UNITED STATES PATENT AND TRADEMARK OFFICE

APPLICATION NO.	FILING DATE	FIRST NAMED INVENTOR	ATTORNEY DOCKET NO.	CONFIRMATION NO.
10/725,623	12/01/2003	Michael M. Kamrava	5603P001X2	4992

Office Action Summary

DETAILED ACTION

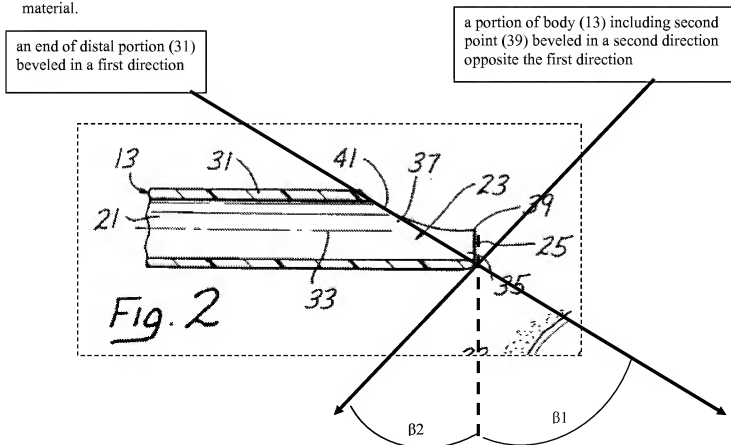
longitudinal axis of the delivery member (30), thus, the distal portion of the distal delivery section (31) defines a second different axis of symmetry throughout the passage a first axis of symmetry. The Gobby device does not disclose the distal passage portion of the delivery section (51) is beveled. Bacich discloses a transfer catheter body (13) comprising a proximal portion (27), a distal portion (31), an elongated passage (21), the distal portion (31) having an end that is beveled in a first direction across the passage (21), a portion of catheter (13) including a second point (39) is beveled in a second direction opposite the first direction defining a tip, showing by $\beta 1$ & $\beta 2$ below. Therefore, it would have been obvious to one skilled in the art during the time of this invention to modify the Gobby's distal passage portion of the delivery section (51) such that it would beveled, taught by Bacich, as such would not only facilitate the delivery process but also serve as a tool cutting through the endometrial lining when delivering the productive material.

Regarding claims 2 & 3 and 14 & 15, particularly to claims 3 & 15 reciting the beveled opening angled between 10° to 15°, Figure 2 illustrates such opening angle range.
